Proposed Residential Development

Stage 1 Road Safety Audit

Client	Longview Estates Ltd.
Project Title	Proposed Residential Development – N7 Longview Estates
Document Title	Road Safety Audit – Stage 1
Document No.	24083HD_Doc 11_Stage 1_RSA
Job No.	24083HD

Fig 2.1

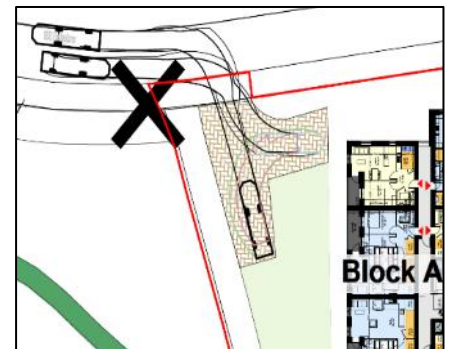
The drawings issued to the audit team shows a turning head at the north western corner of the site. It is unclear from the drawings as to the purpose of this tuning head and frequency of use. If this is to be a permanent feature, the turning head could become an unofficial parking area and lead to collisions between vehicles exiting and pedestrians. Refer to Fig 2.1

The Design team to review layout and the purpose of the junction and turning head.

Fig 2.2

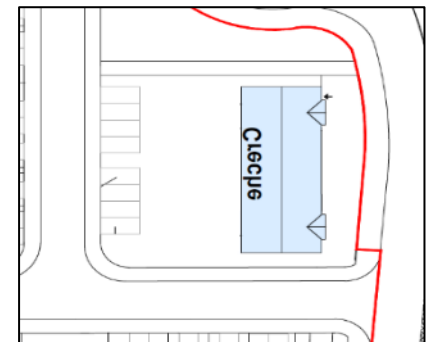
The audit team observed inconsistencies in the drawings in reference to the parking and set-down area for the Creche. Refer to Fig 2.2 as it appears to have no set-down area. If it is proposed to not provide a set down area, this could lead to road safety issues with parked vehicles during the peak drop off and pick up times.

The design team to review the parking and set-down area to ensure the design is in accordance with relevant standards.

Fig 2.3

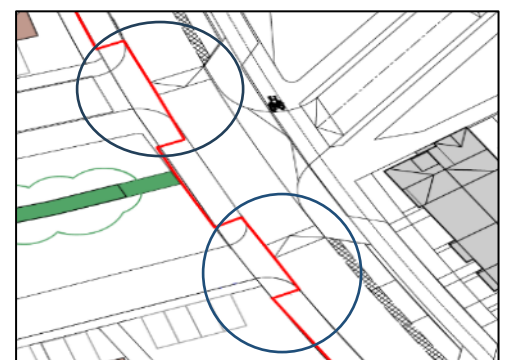
There appears to be a conflict between the 3rd and 4th entrances and the raised table location shown. The raised table appears to stop in the middle of both junctions (where the parking bays end). The location of these existing parking bays could result in side impact type collisions between vehicles turning out from the car spaces to exit the development and vehicles exiting the new junctions. Refer to Fig 2.3

The design team to review the junctions design and interaction with the existing parking bays to ensure they are designed in accordance with relevant standards.

2.1	Y	Y		
2.2	Y	Y		
2.3	Y	N	The raised table has been removed from the junction design. Raised pedestrian crossings positioned to the north and south of the junction are incorporated instead which serve as traffic calming measures for this length of road. The existing parking bays avail of good forward visibility in a low speed environment which should greatly reduce/ remove any risk of side impact collisions between vehicles turning out from the parking spaces and exiting the new junctions.	Yes

Fig 2.5

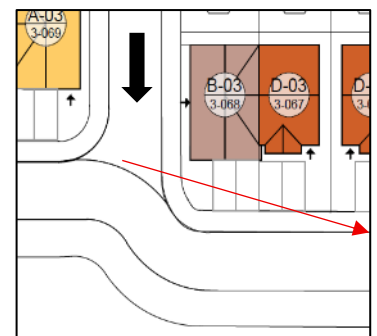
Vehicles traveling south from House 3-08 in the directions of the arrow shown in Fig 2.5 may have their sightlines to vehicles coming from the East restricted by a car parked outside of house 3-068. This could lead vehicle on vehicle side impact type collisions between vehicles pulling out at the junction and vehicle travelling internally within the development.

The design team to ensure adequate sightlines are provided for all junctions within the development.

Fig 2.6

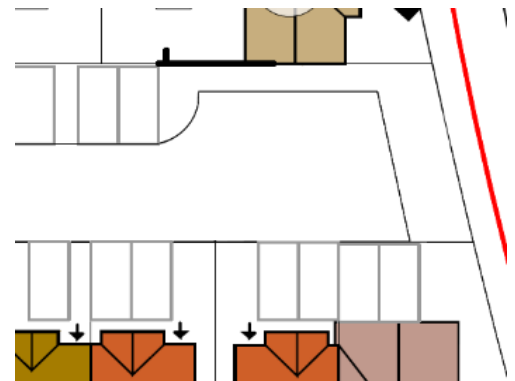
The hammer head provided in the site layout at House No 2-040 appears to be very small in nature. An inadequate size turning head could pose a road safety risk to all road users if vehicles are required to undertake multiple manoeuvres to turn around. Refer to Figure 2.6

The design team should run an Auto track at this and all turning points within the development to ensure they are adequately sized for larger vehicles.
